Model: <b>GR-C3</b>	Date: 15-Nov-16	No.: RD296002
---------------------	-----------------	---------------

Subject: Firmware Release Note: aics		Prepared by: C. Shimaji	
From: 2nd Tech Service Sect., MFP/Printer Tech Service Dept.			
Classification:	<input type="checkbox"/> Troubleshooting	<input type="checkbox"/> Part information	<input type="checkbox"/> Action required
	<input type="checkbox"/> Mechanical	<input type="checkbox"/> Electrical	<input type="checkbox"/> Service manual revision
	<input type="checkbox"/> Paper path	<input type="checkbox"/> Transmit/receive	<input type="checkbox"/> Retrofit information
	<input type="checkbox"/> Product Safety	<input checked="" type="checkbox"/> Other (Firmware)	<input checked="" type="checkbox"/> Tier 2

This RTB has been issued to announce the firmware release information for the **aics**.

**4. Replacement and Adjustment > Fusing > Actions When SC544-00 or SC554-00 Occurs (P270)**

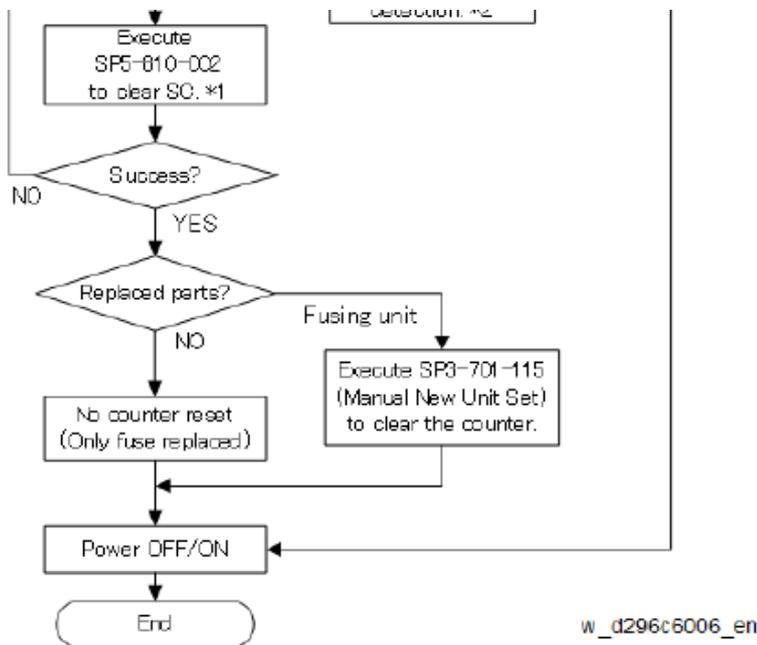
The following sentence is incorrect, so please correct your field service manual as follows.

● **Notes for installing the NFC Card Reader Type M13**

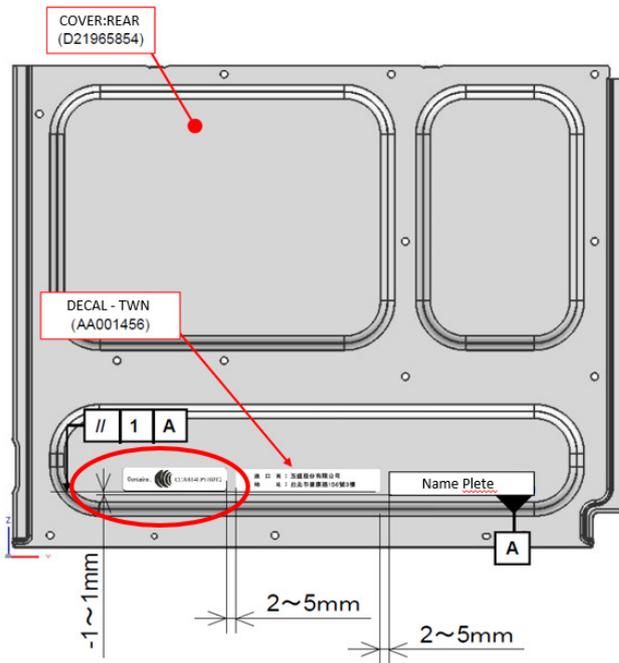
Please attach the following decal to the rear cover when installing NFC Card Reader Type M13 for GRI-C3 to apply NCC (National Communications Commission).

- 2. Installation > NFC Card Reader Type M13
  - Add this decal to the Component List
  - Add the attachment procedure of this decal

**a) 2. Installation > Anti-condensation Heater (for Mainframe Paper Tray) > Installation Procedure (P.87)**

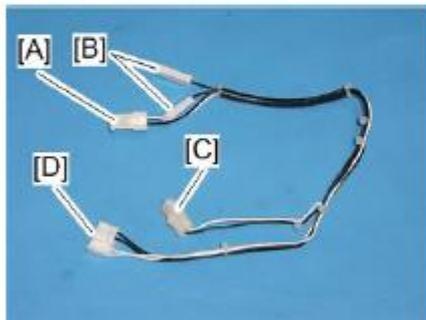
Please apply the following two corrections to your FSM:

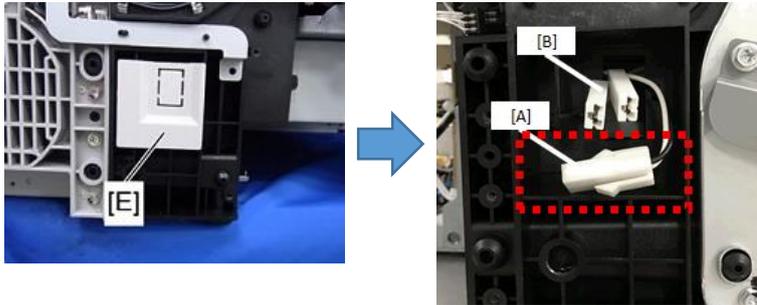
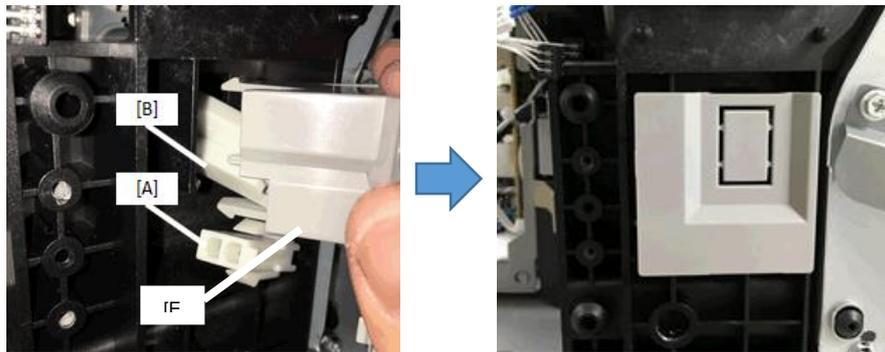
- Remove the cover [E], and then pull out the junction harness connectors [A] and [B].
- Store the connector [A] in the open space shown below.

- Store the connector [B] into the cover [E], and then attach the cover [E].

**b) 2. Installation > Anti-condensation Heater (Optional Paper feed unit) > Installation Procedure (P.94)**

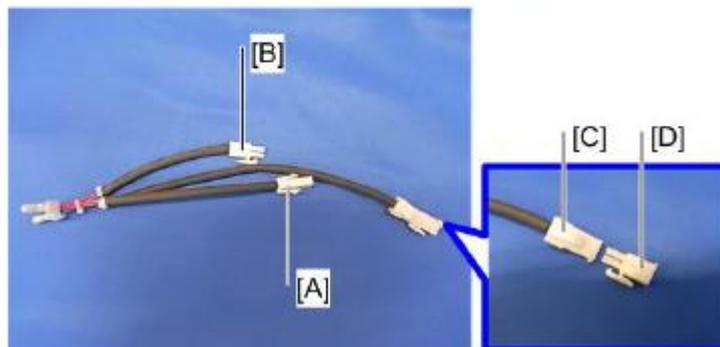
- A: For this tray heater
- B: For the mainframe
- C: For another optional tray heater
- D: Isolation cap (uncap if installing the heater for 2nd paper tray)

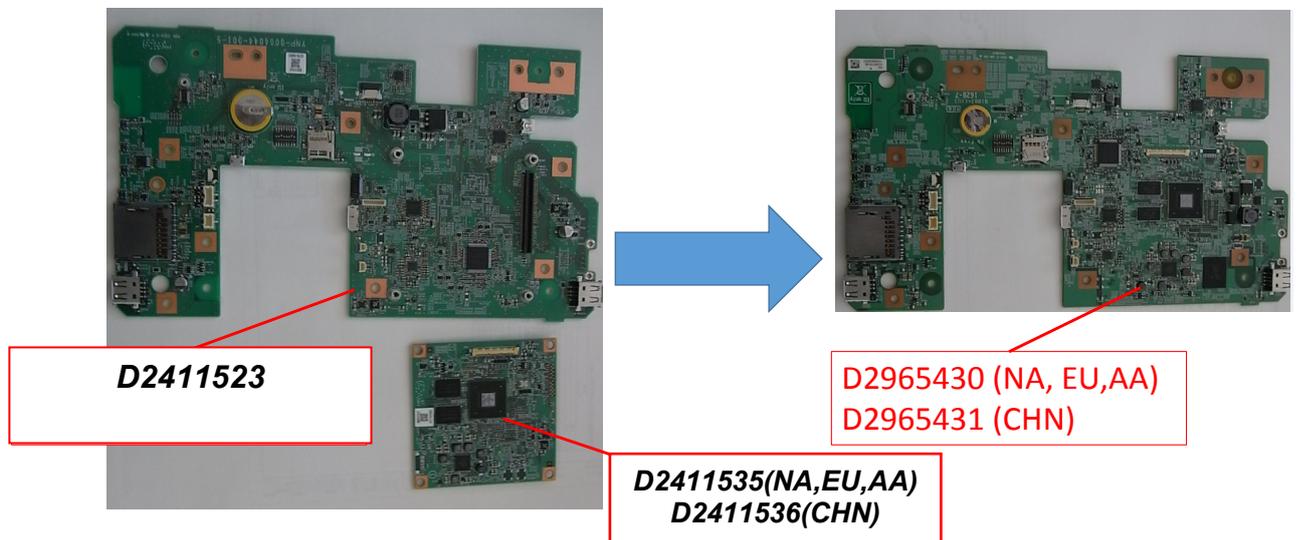
**Reason:** Change of the Supplier

Following has to be concerned when replacing the PCB of the Smart Operation Panel.

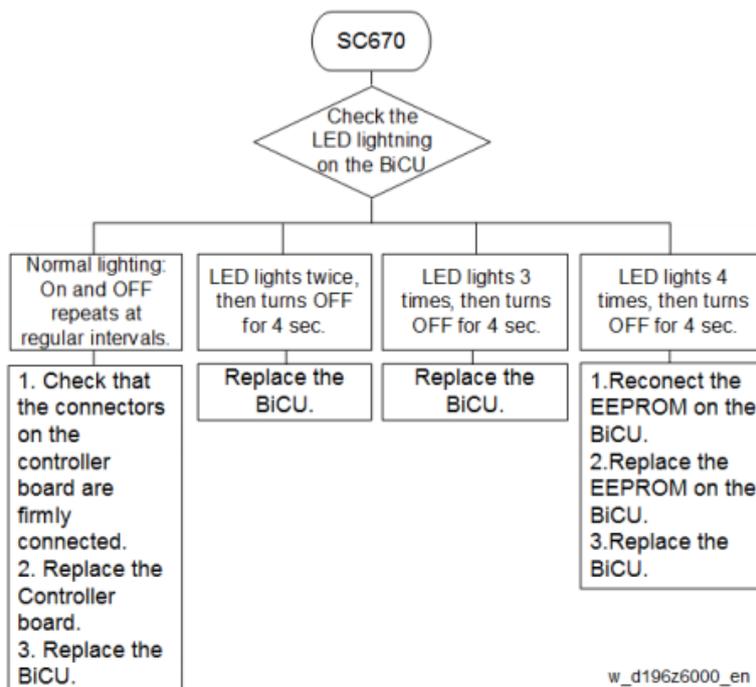
No	Type	Details (Symptom, Possible Cause, Troubleshooting Procedures)
SC670-02	D	Engine is down when machine starts up (SC reboot can not be performed) (* See "When SC670 Is Displayed" below)
		Machine-down was detected after the /ENGRDY signal was not asserted
		The engine board was reset at an unexpected time
		Check the connection between the engine board and the controller board. <ul style="list-style-type: none"> <li>• If it is always reproduced, replace the engine board. If the problem persists, consider replacing the controller board or other boards between them.</li> <li>• If reproducibility is low, multiple causes are to be considered, such as software, engine board, controller board, and PSU</li> </ul>
		<b><i>Check the status of ID chip in each toner cartridge (clean or correct the position).</i></b>

**Point to Point Revision**

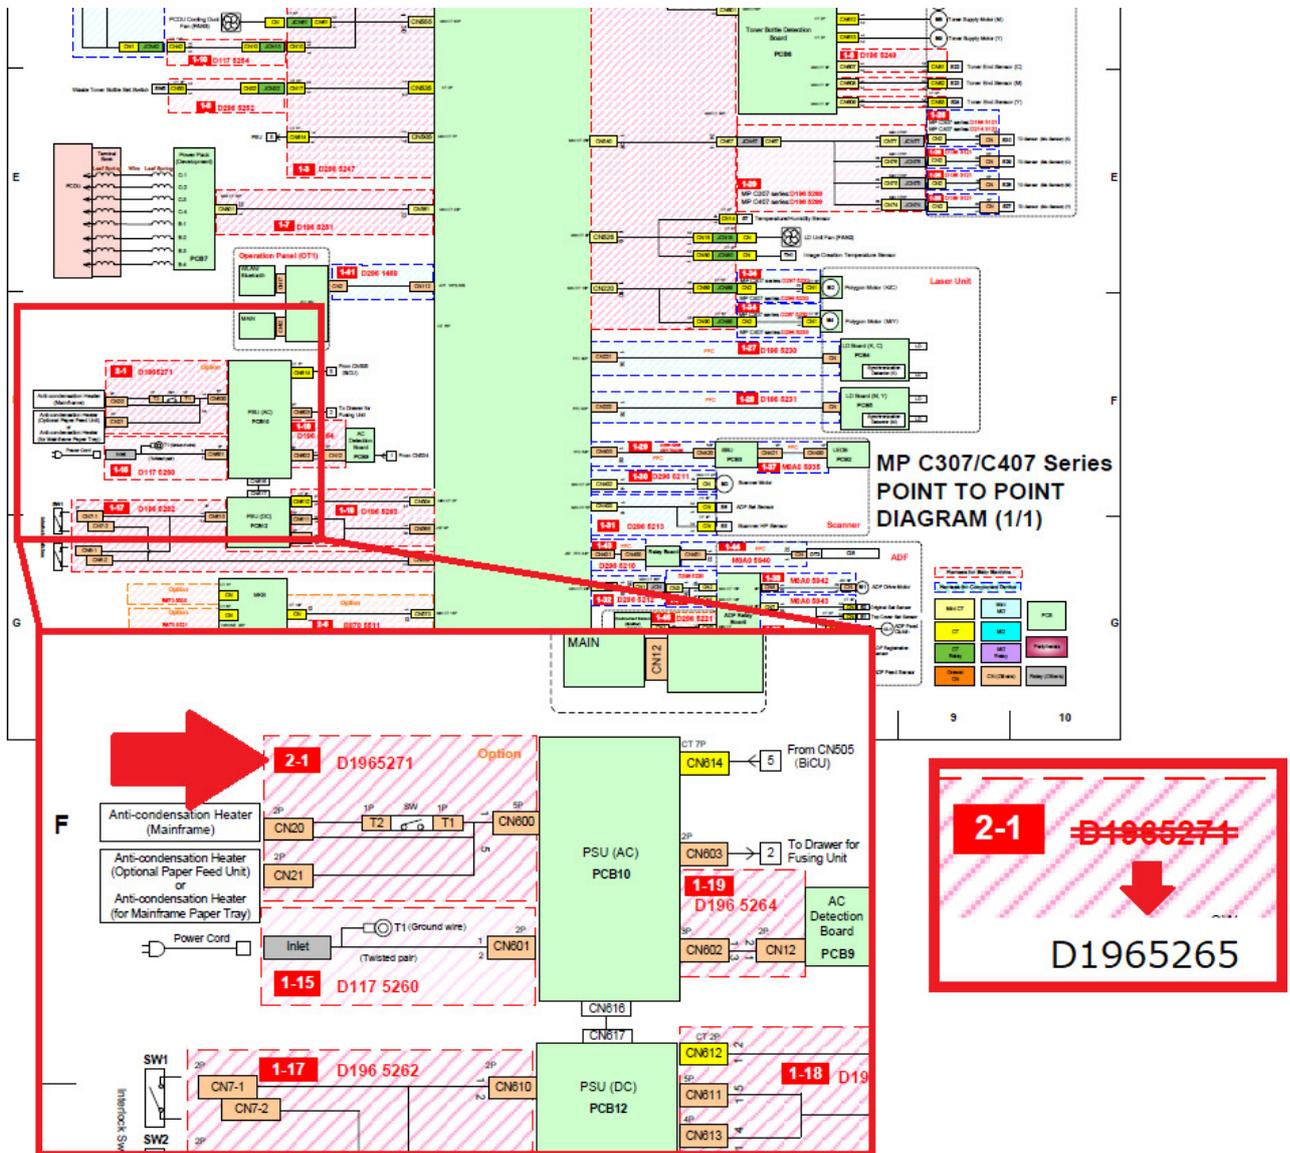
The part number (D1965271) of the harness, which runs from the PSU(AC) to the Anti-condensation Heater, is incorrect.

For the incorrect part number in Point to Point, refer to the figure below.

The correct part number is D1965265.

**RTB Reissue**

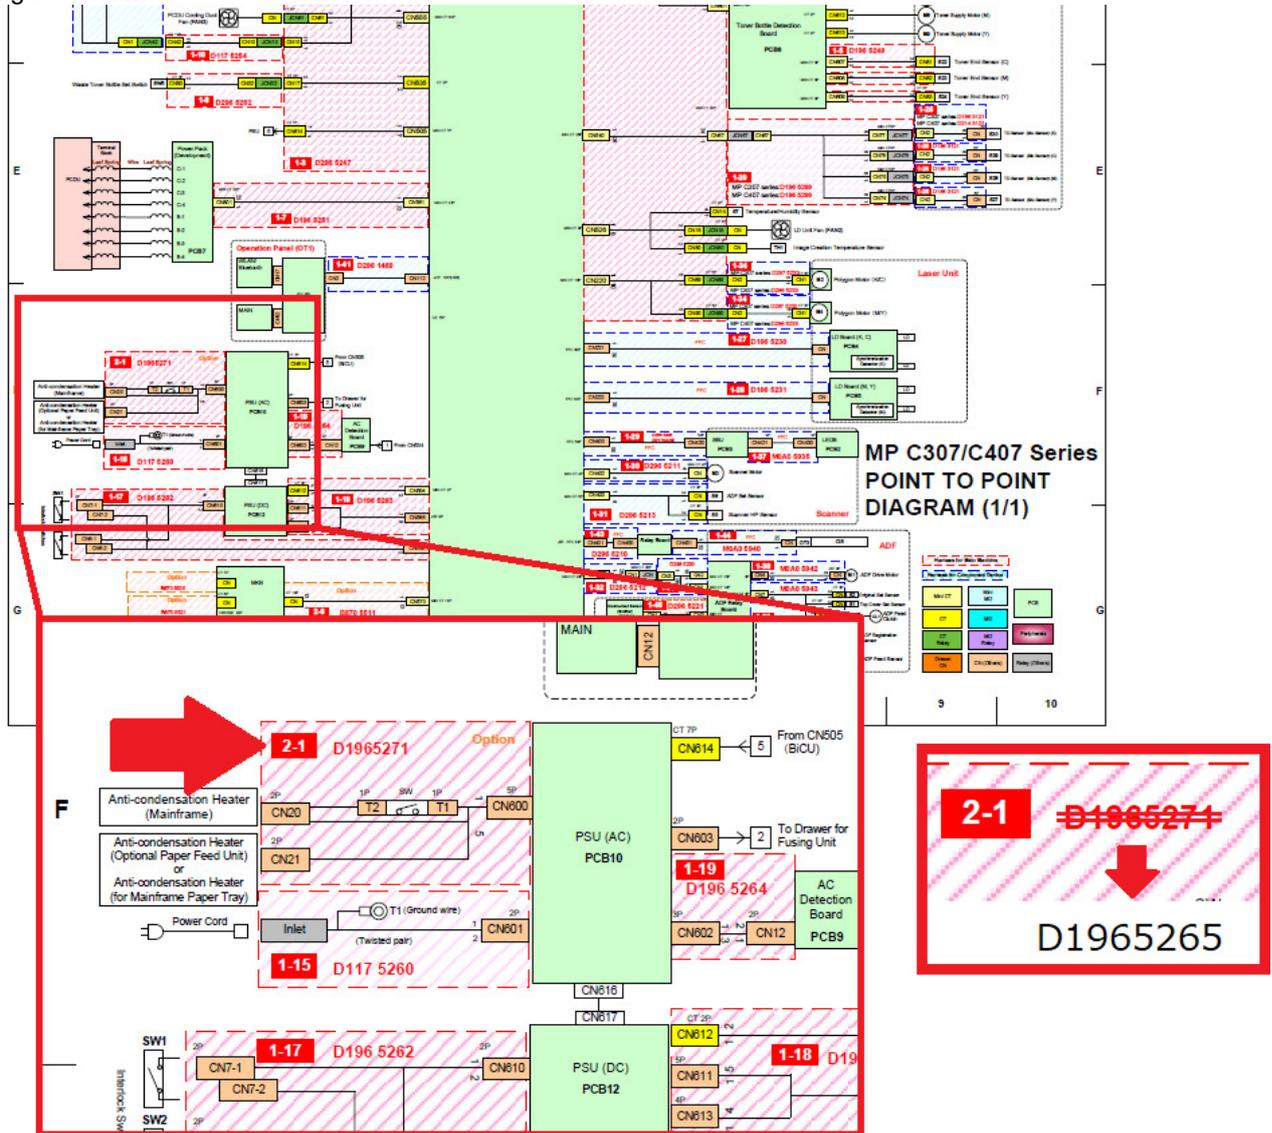
The part number (D1965271) of the harness, which runs from the PSU(AC) to the Anti-condensation Heater, is incorrect. The correct part number is D1965265. For the incorrect part number in Point to Point, refer to the figure below.
